CIRCLE SQUARE PLOTS 2, 3 + 4
(FORMERLY KNOWN AS BBC SITE)
OXFORD ROAD, MANCHESTER

Non-Material Amendments
April 2020

4.3 Planning Approved Drawing - First Floor

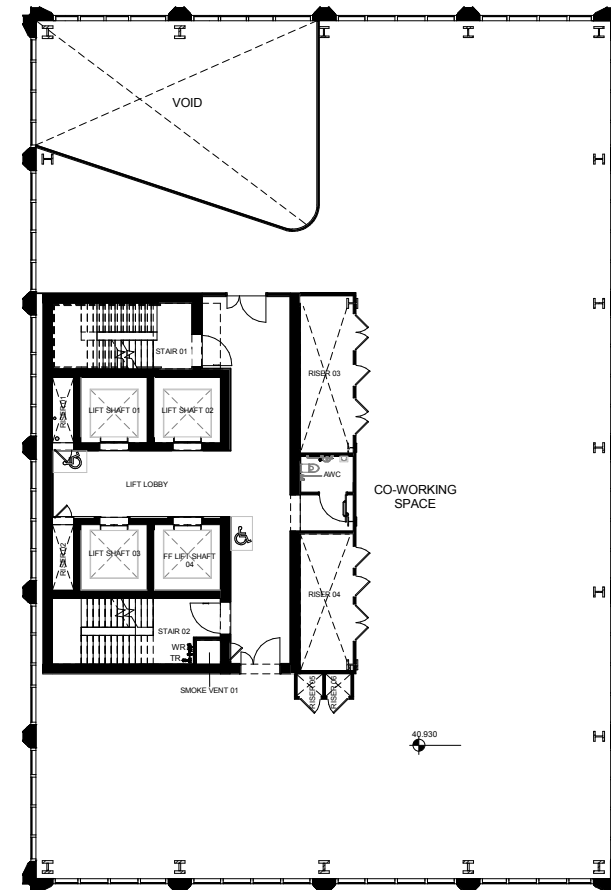
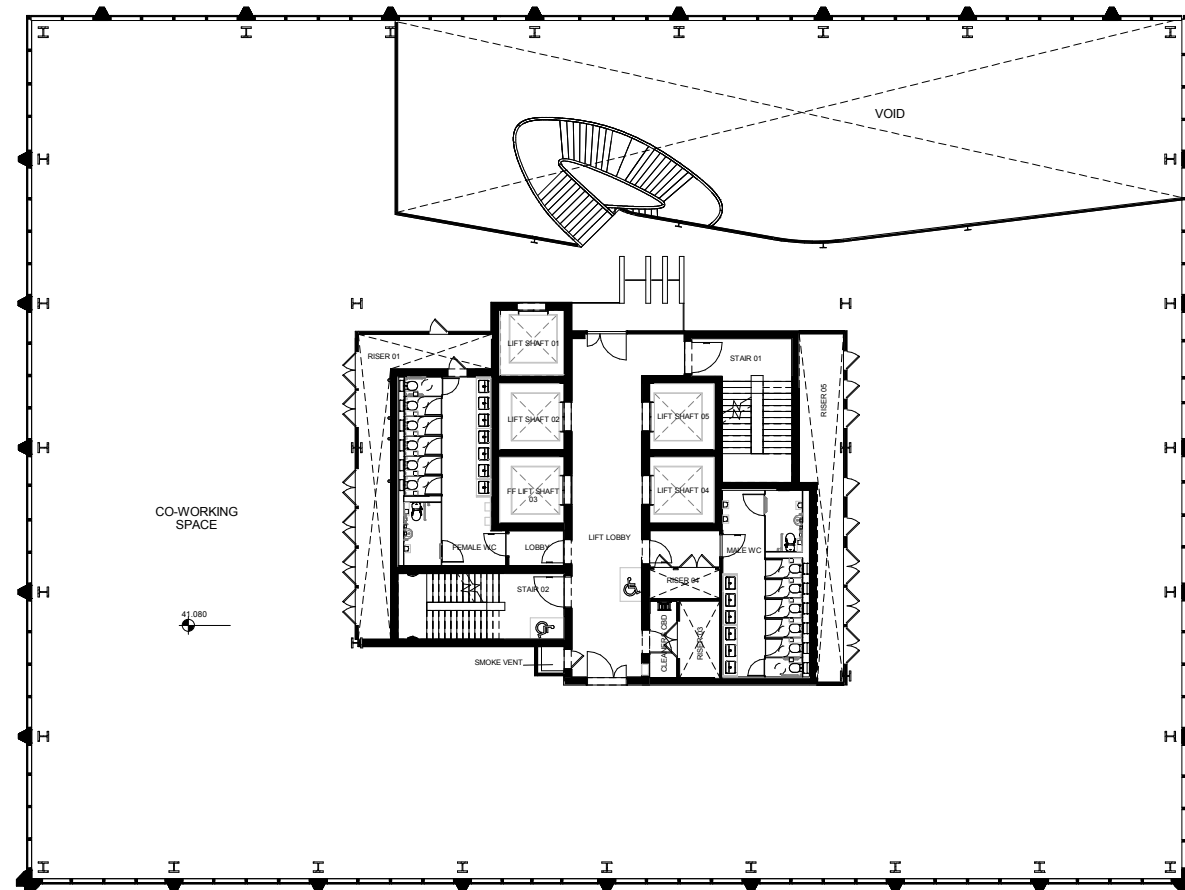
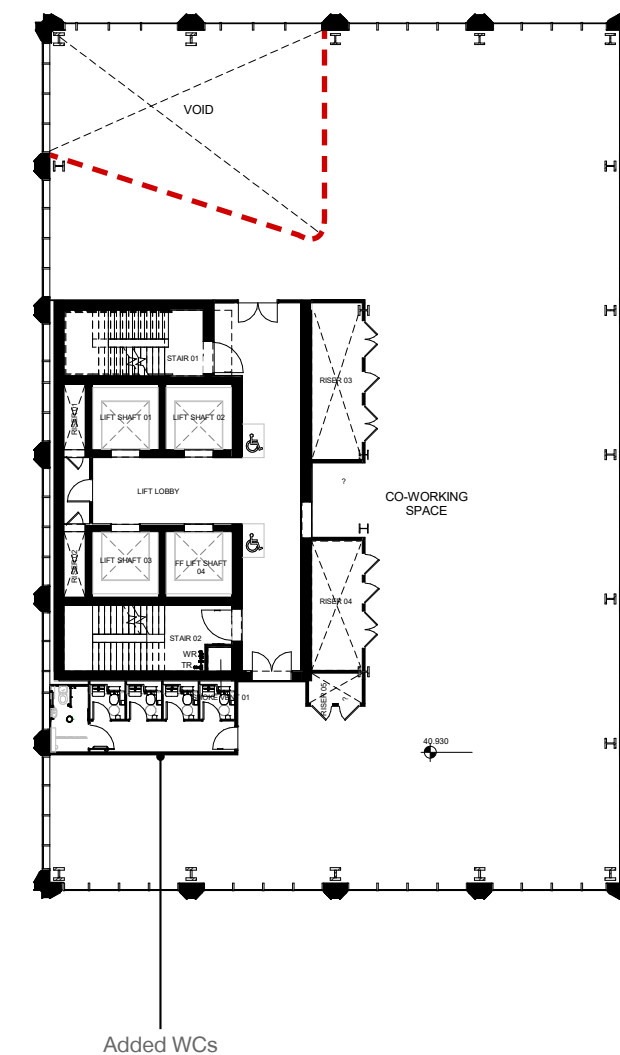
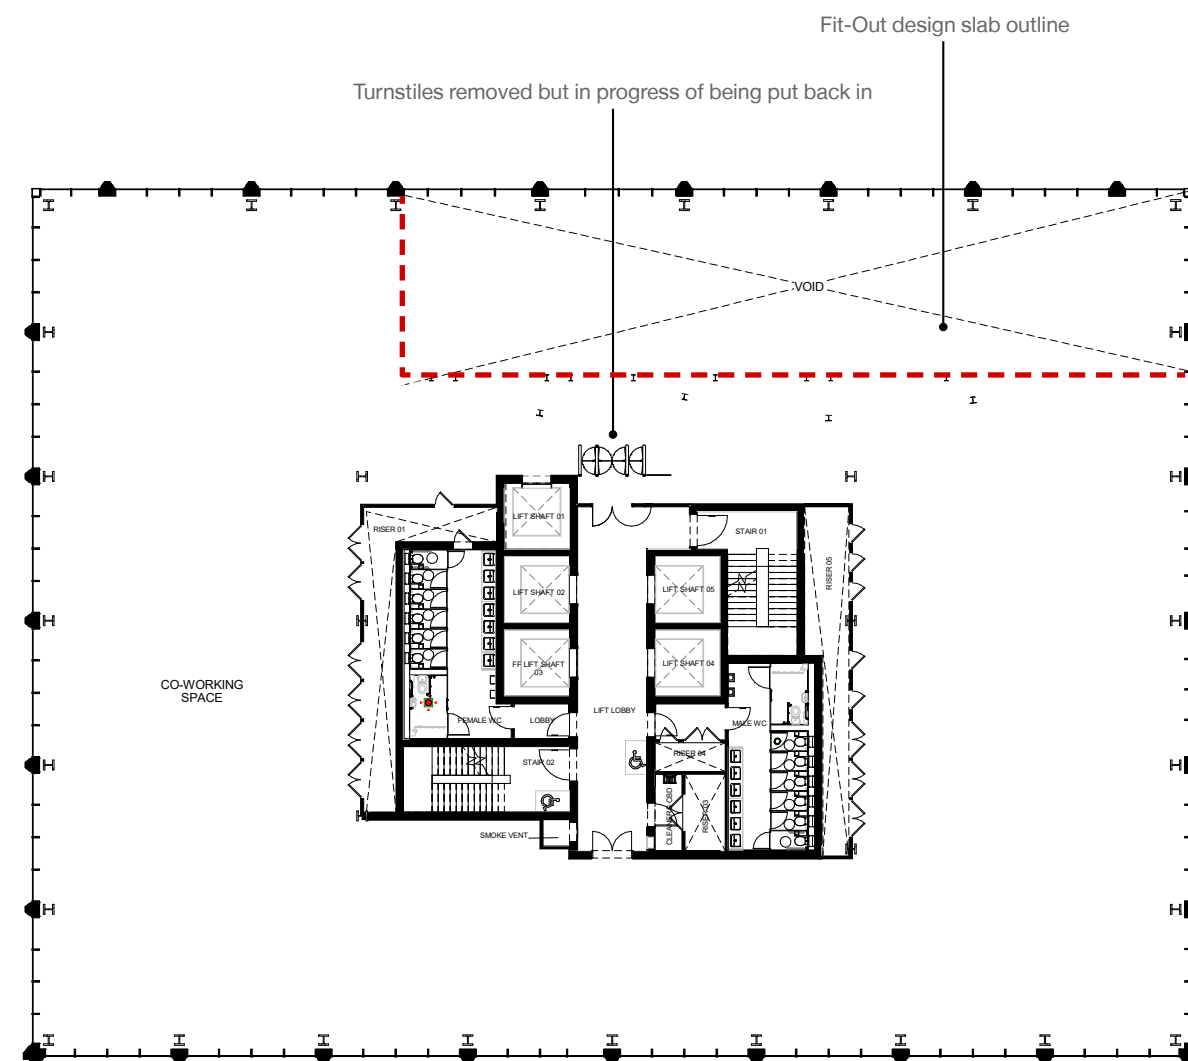
Speed gate arrangement updated and slab outline has been amended following fit-out changes.

4.4 Planning Approved Drawing - Levels 2-4

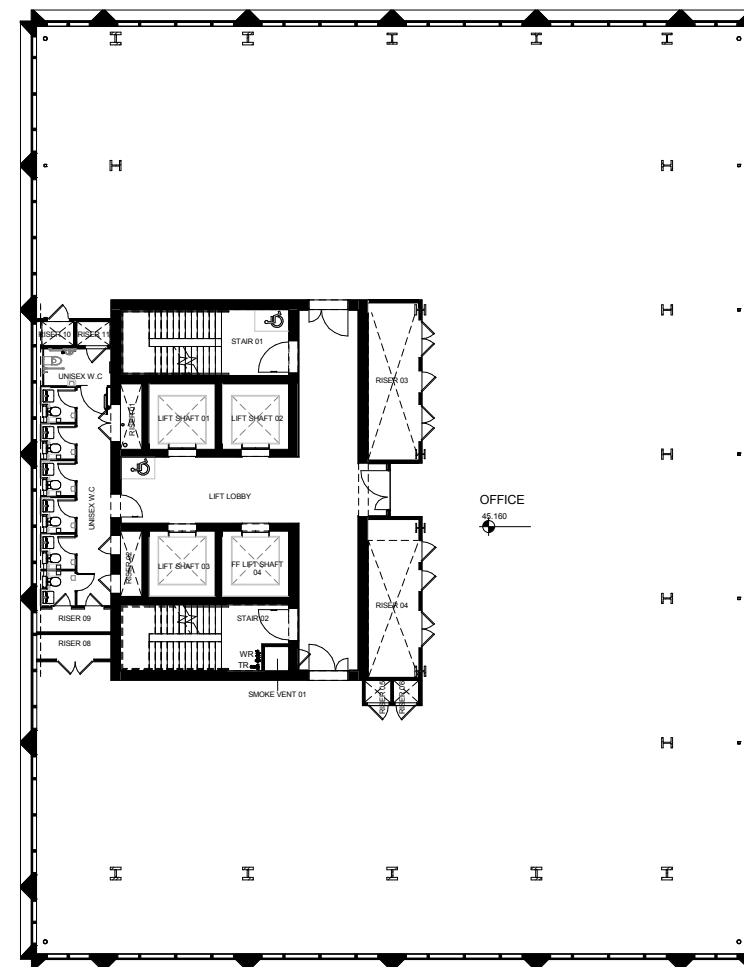
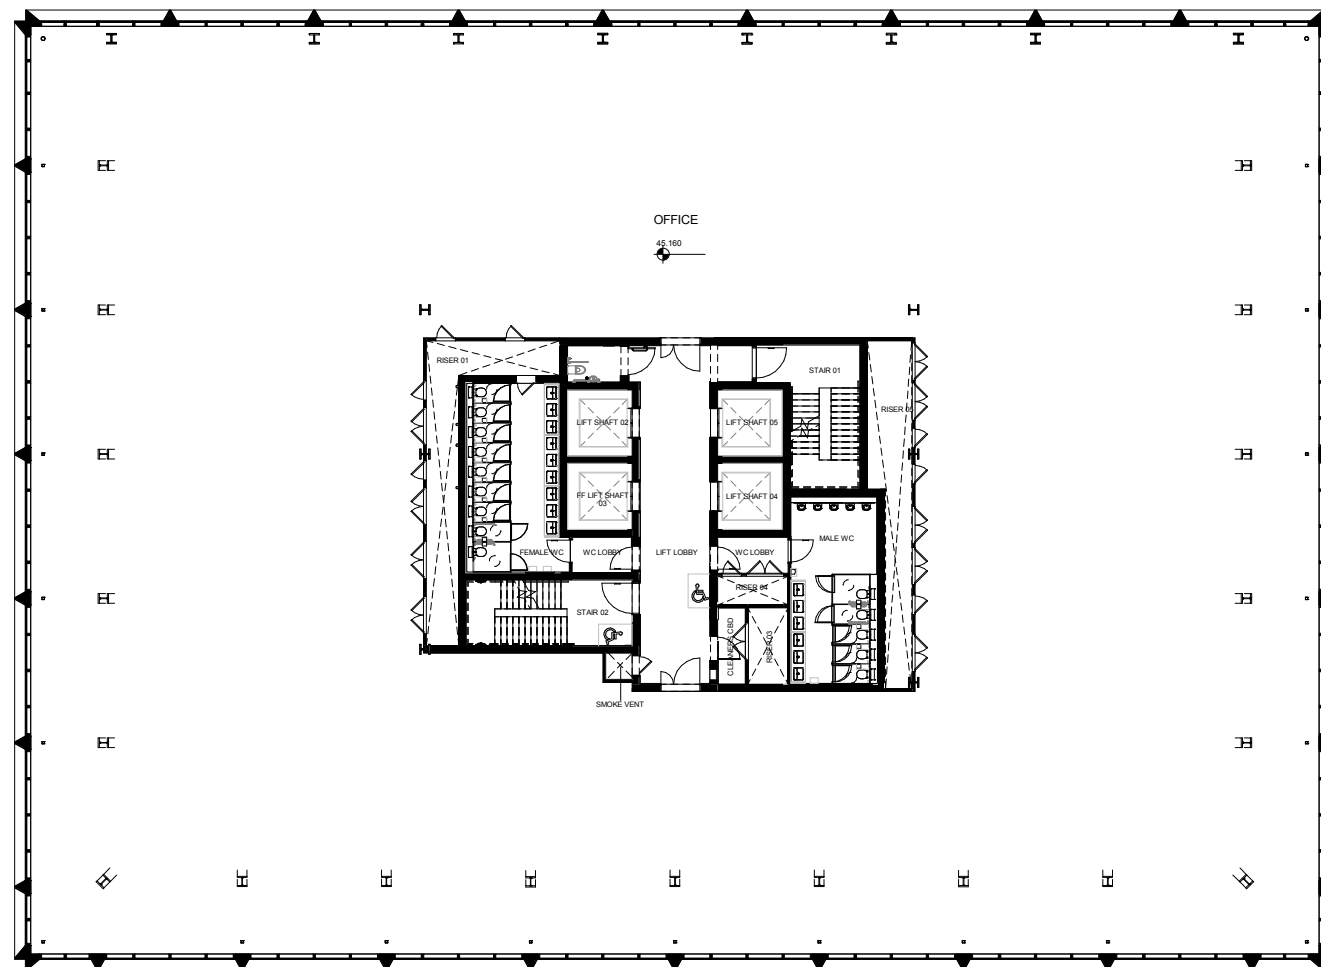
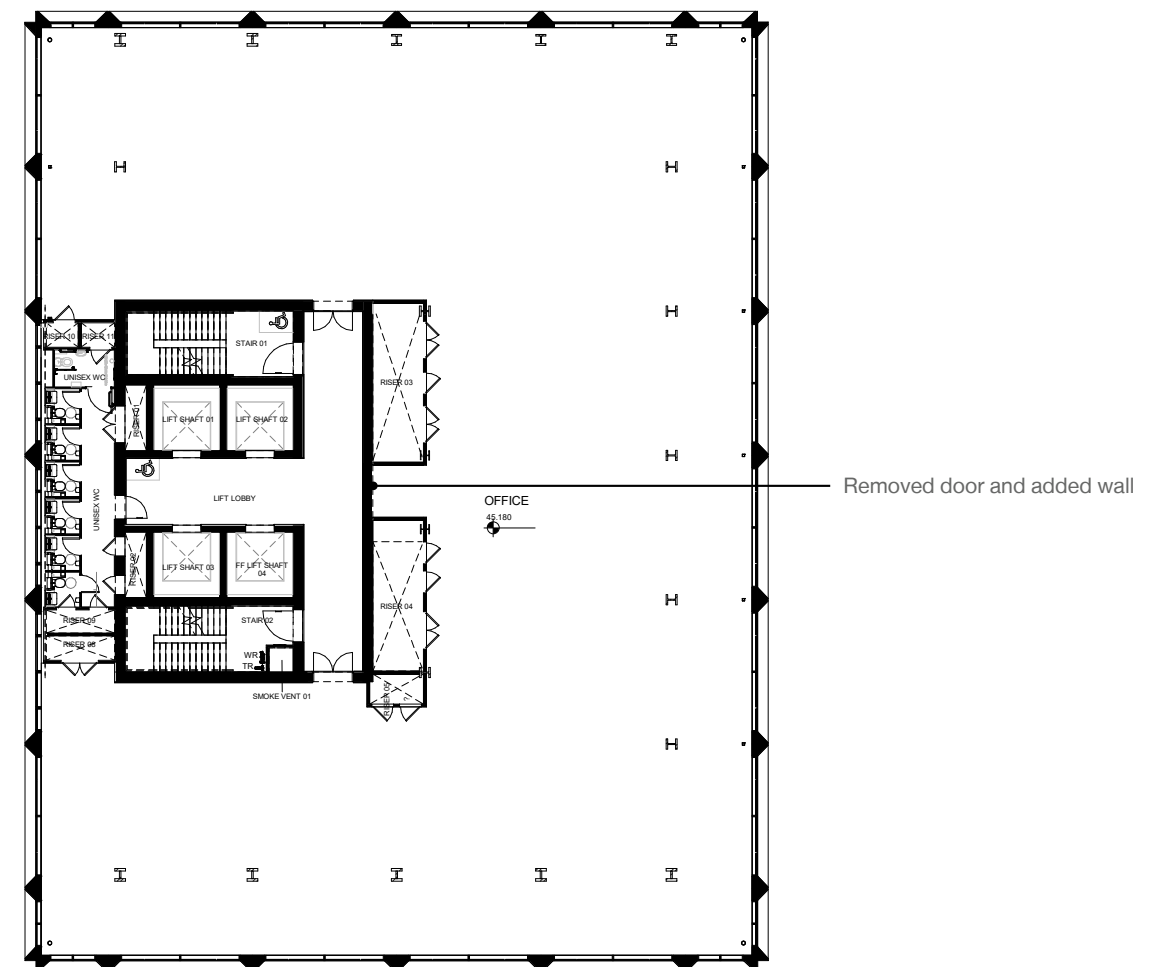
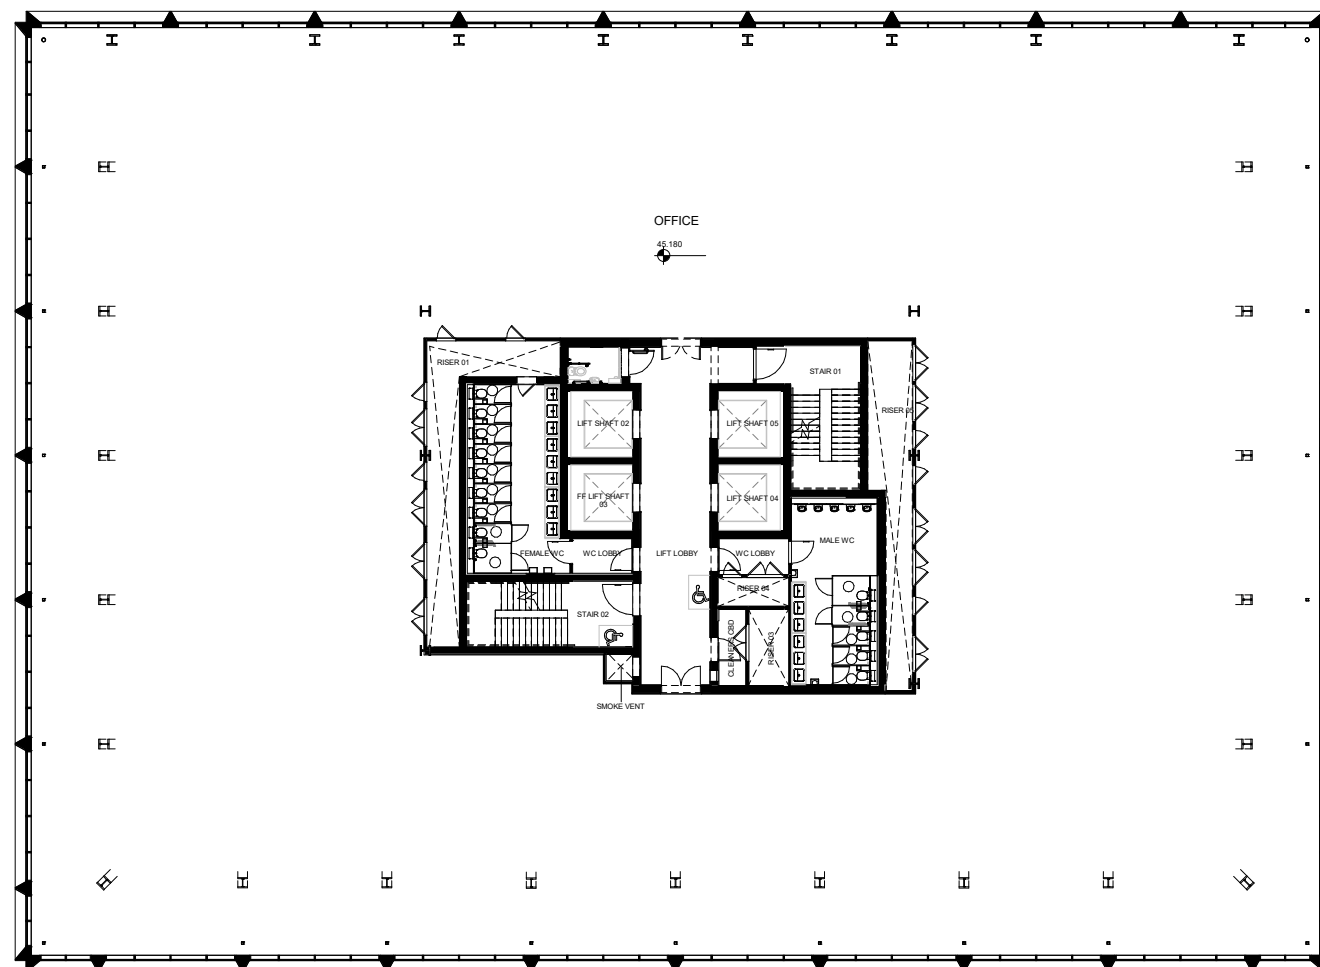
Further to clarity around the fit-out design, the middle door to the core was removed and the wall moved back to align with the lobby internally.
